## WLTP - Development of the Harmonized driving Cycle

A few considerations on the current approach for deriving the WLTC

Figure 15a

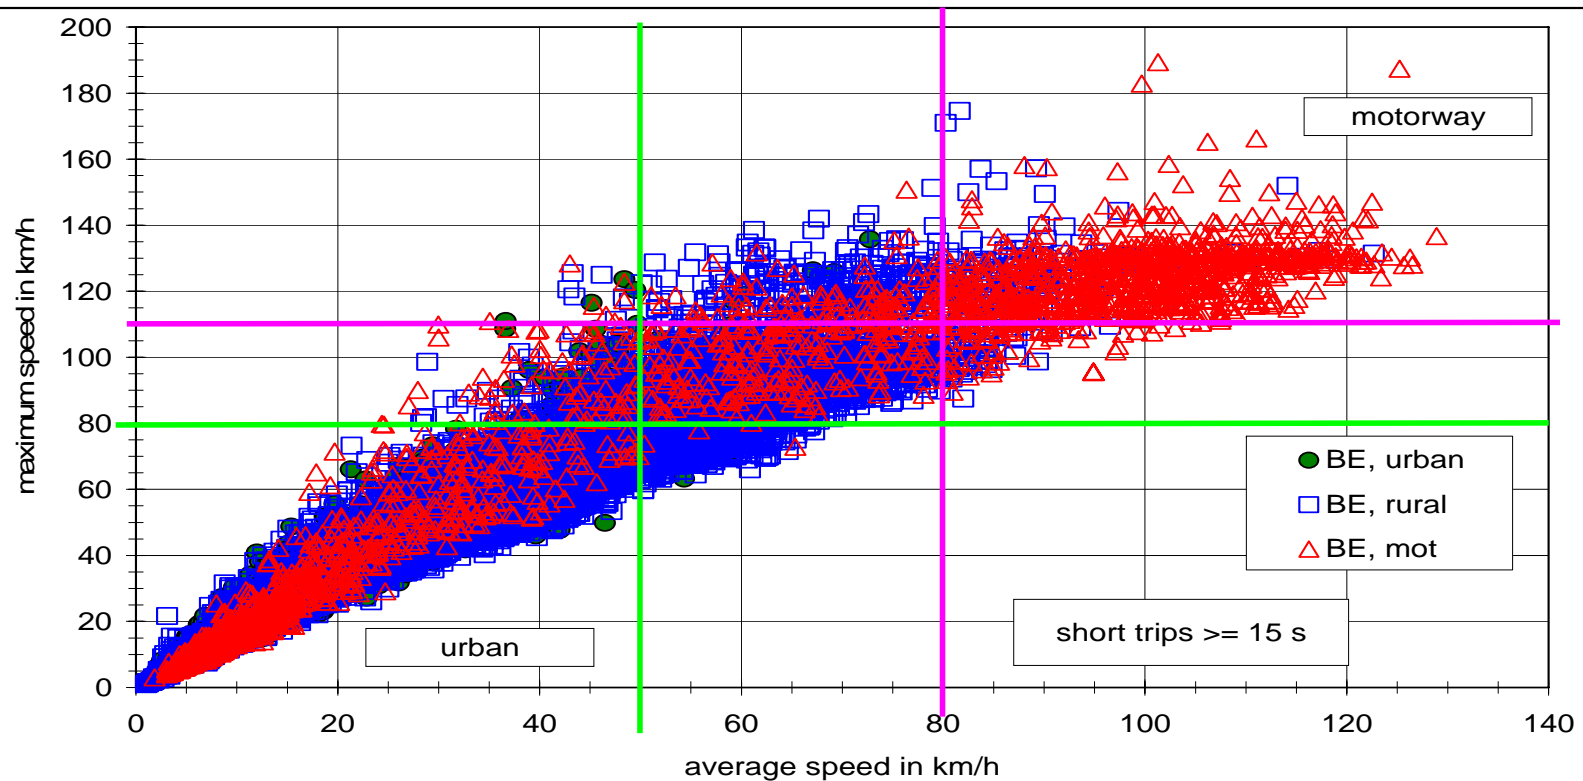
## Max. speed versus average speed
